DEVELOPMENT REVIEW BOARD
SUPPLEMENTAL SUBMITTAL

PROJECT NO. 2022-006547

Application No. SI-2022-00216

RE: Panda Express – S8-22-D8582
10126 Coors Blvd. NW
Albuquerque, NM 87114
RE: DRB Planning Review – 1st Resubmittal
DRB Project Number: 2022-006547
App. Number: SI-2022-00216

C03.2

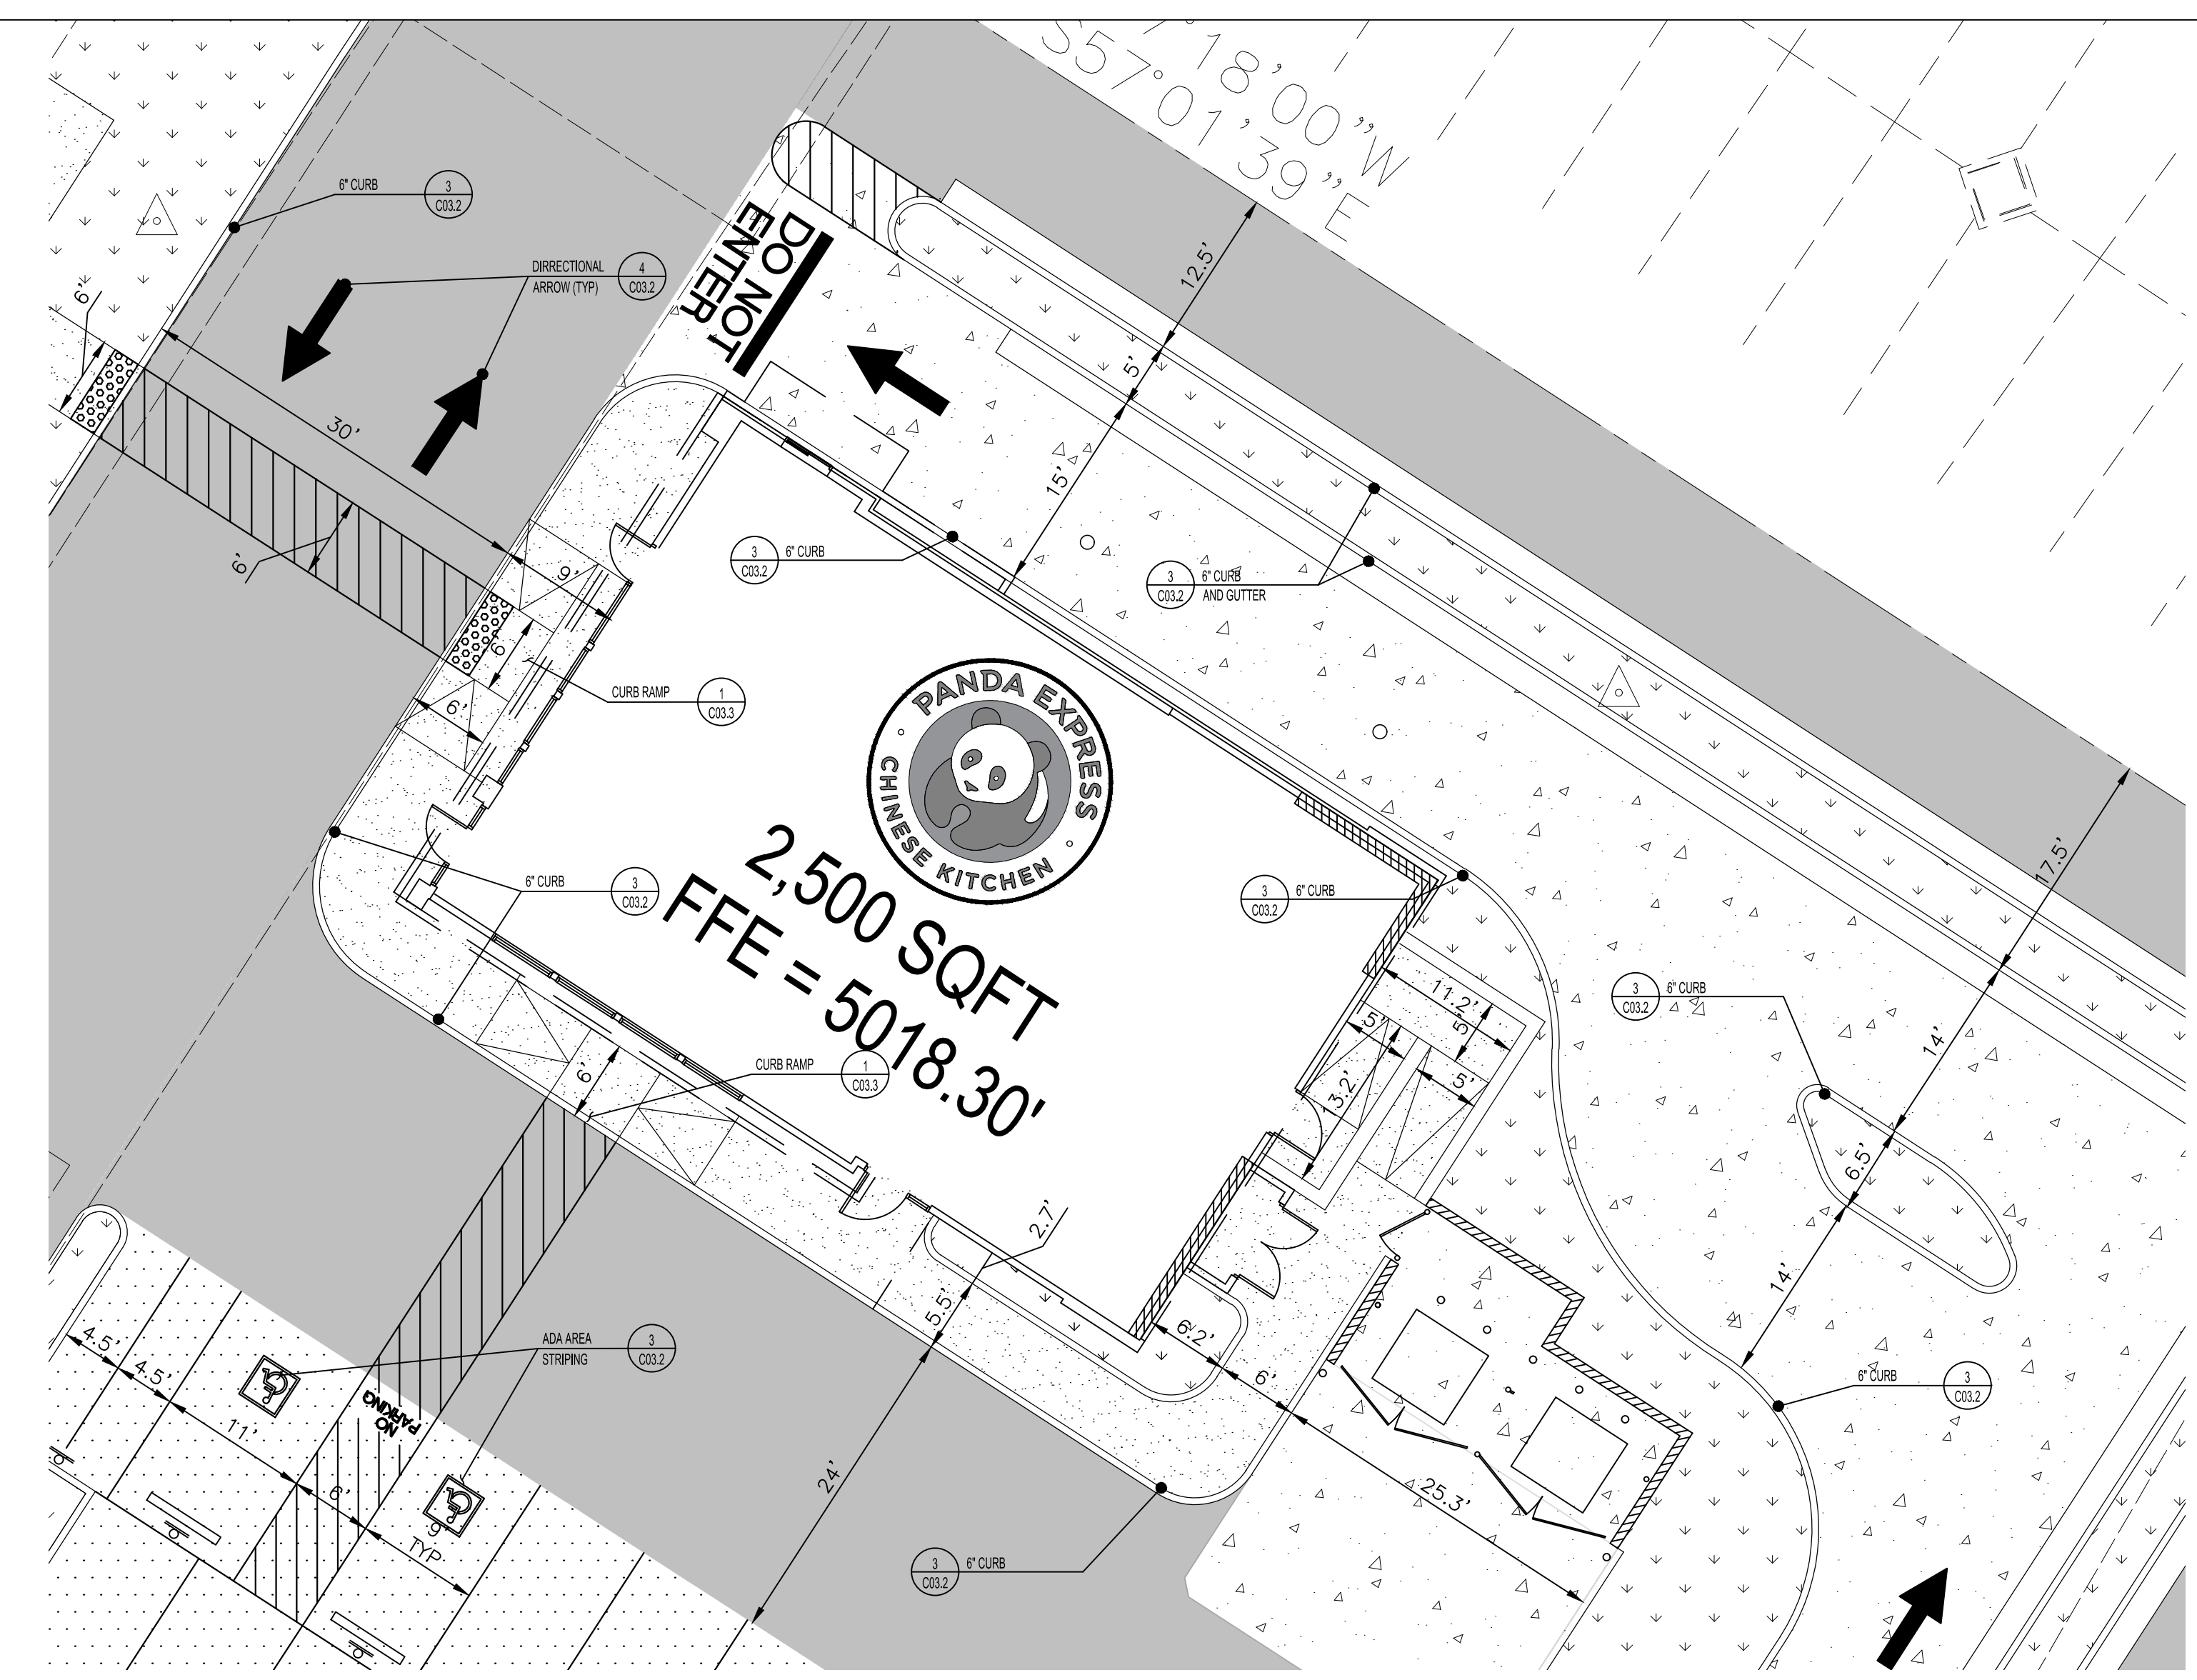
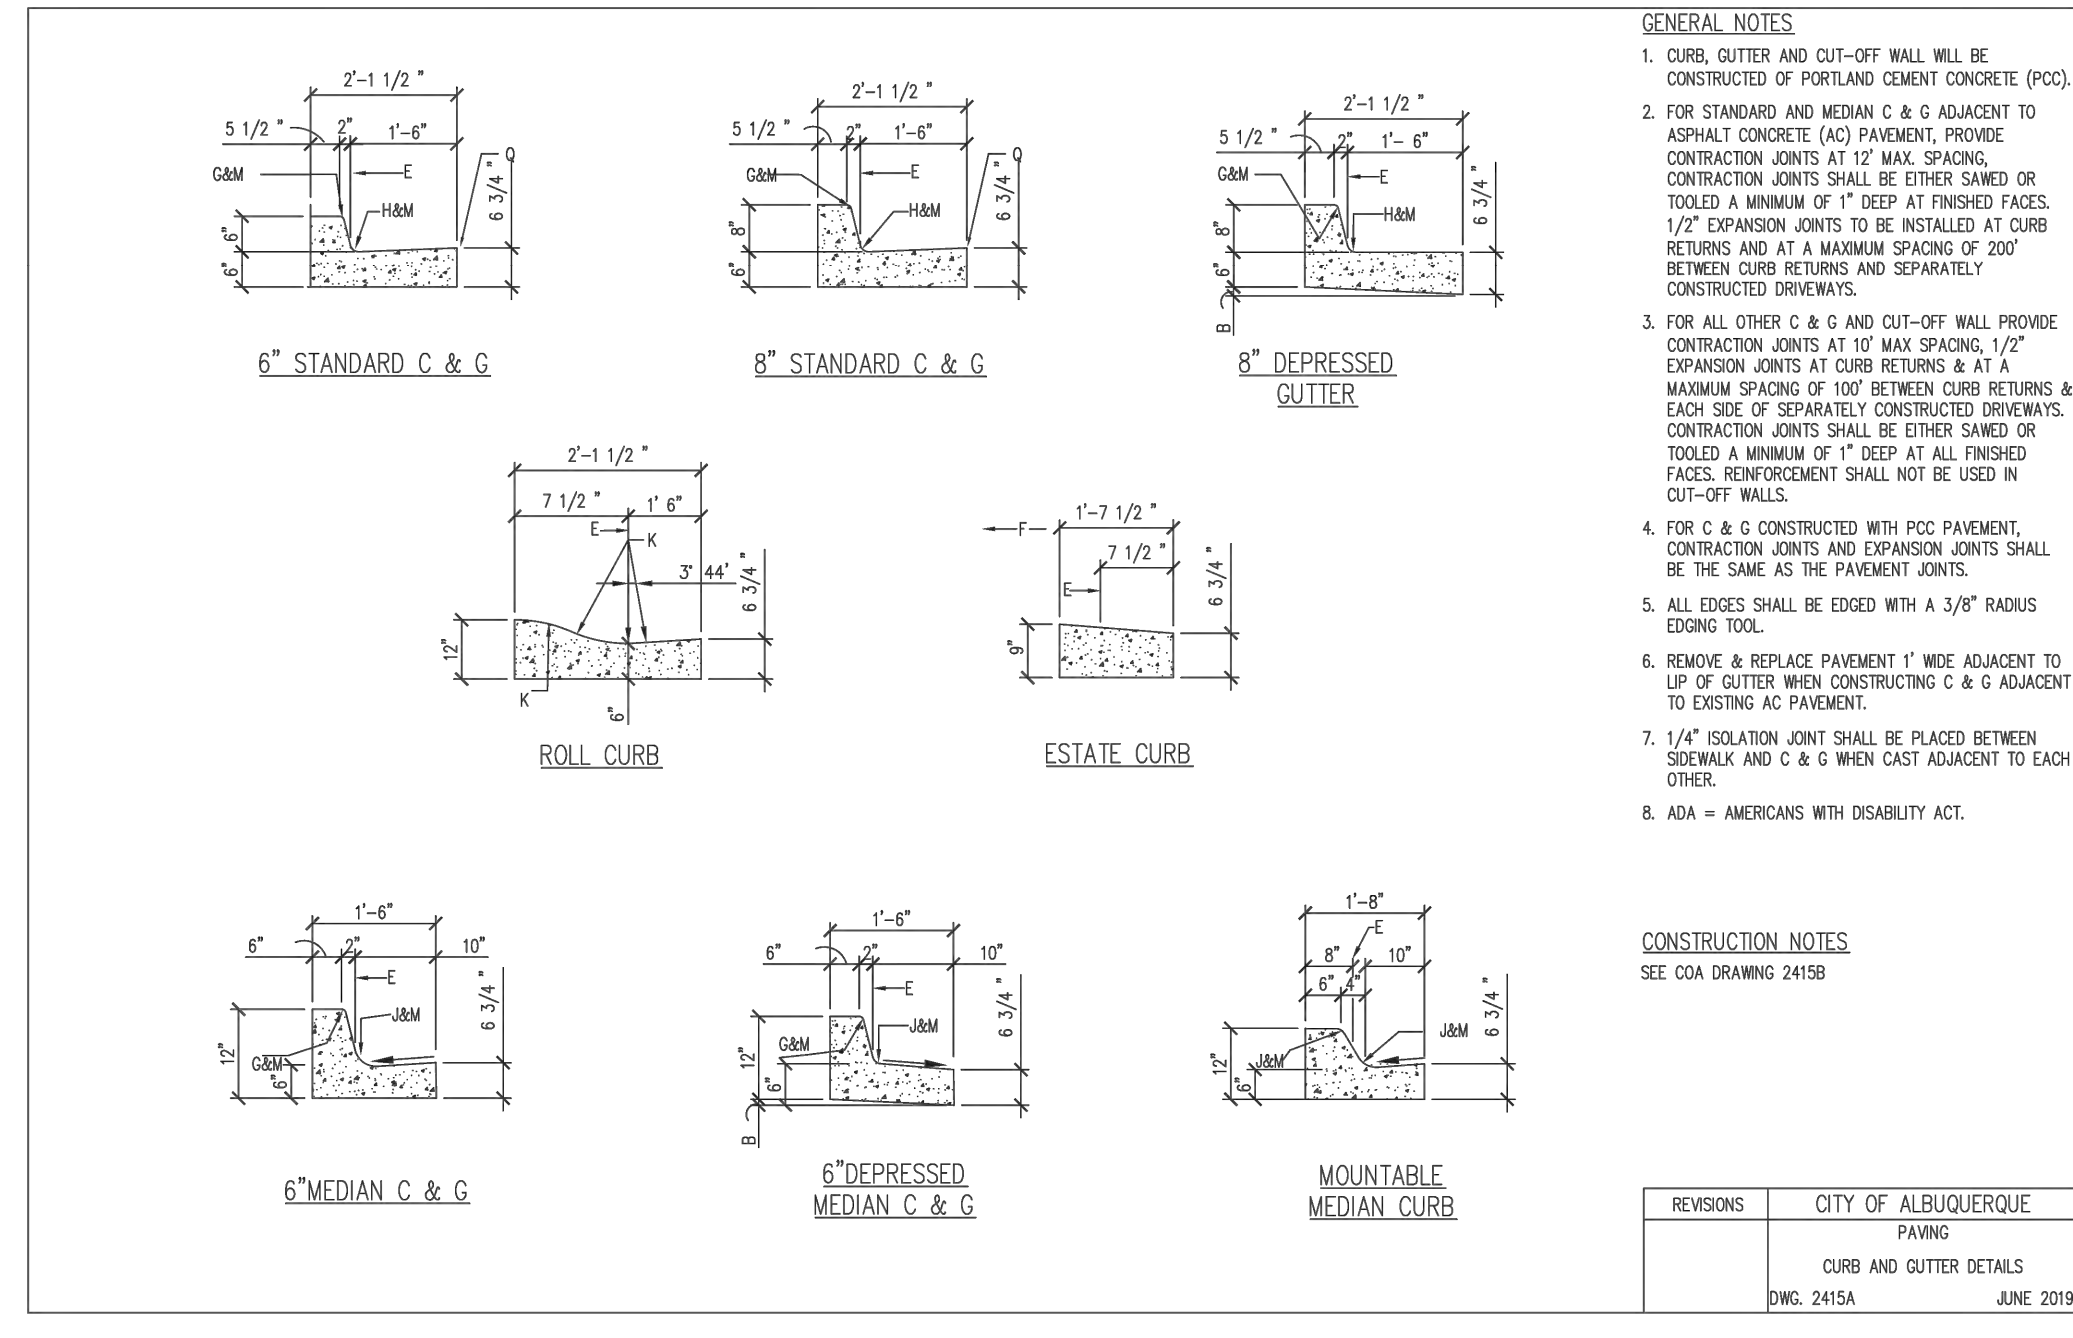
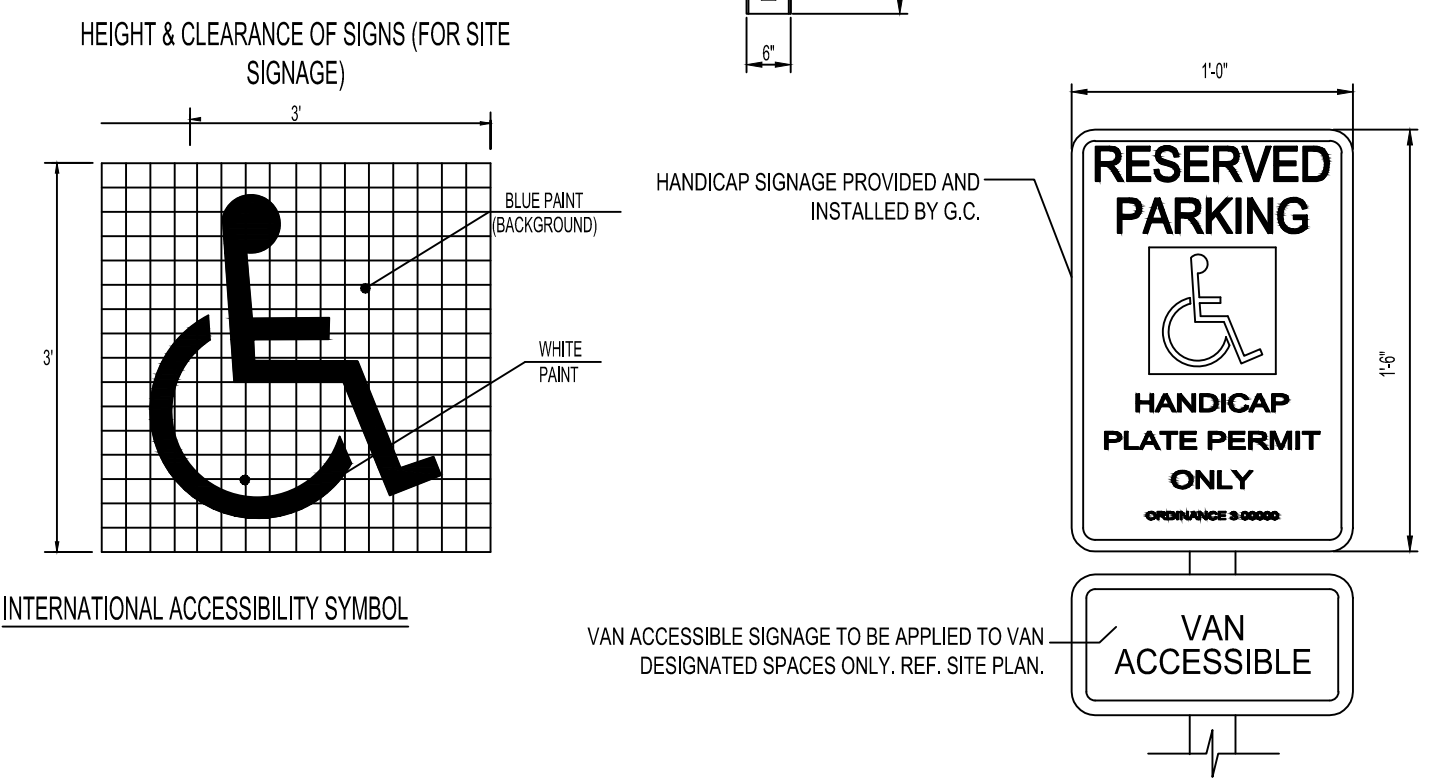
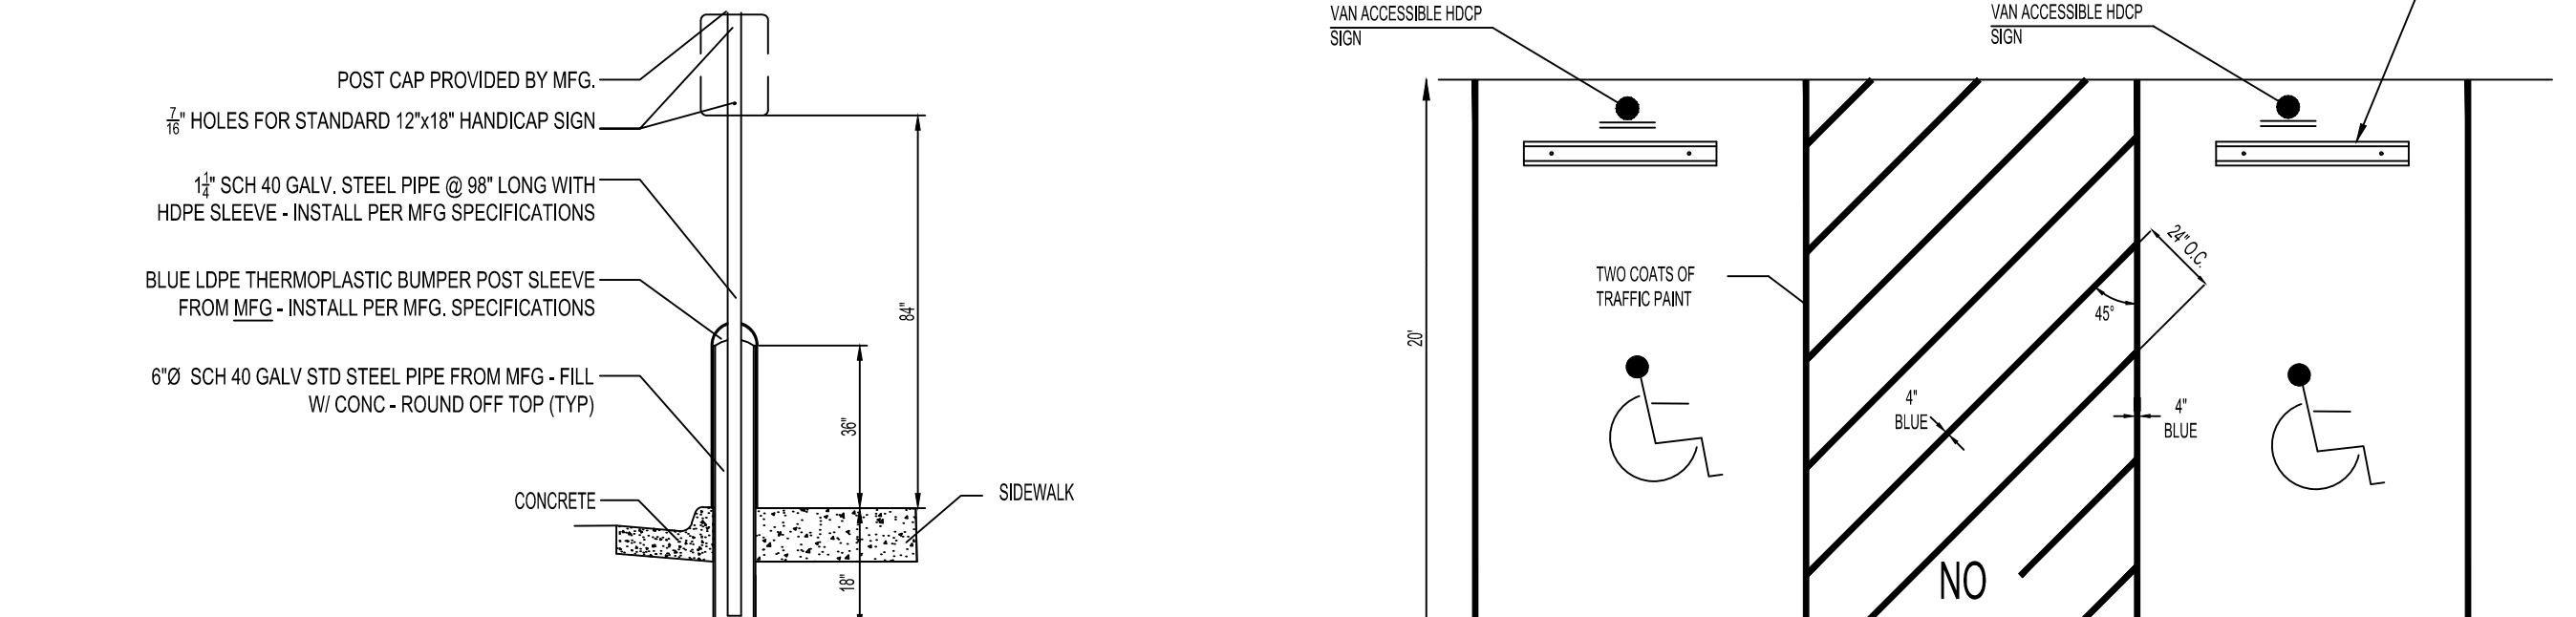
9. Call out curb on the site plan with keyed notes. A minimum 6"-8" curb is required to separate parking lot and spaces from landscaped islands and sidewalk.

10. Provide handicapped signage details, and show "No Parking" on the pavement in the back of the van accessible aisle. Label handicapped spaces with a keyed note on the site plan.

Response: Refer to detail sheets C03.2, C03.3 and C03.4 for further information.

Response: Refer to sheet C03.2 Hardscape Details I
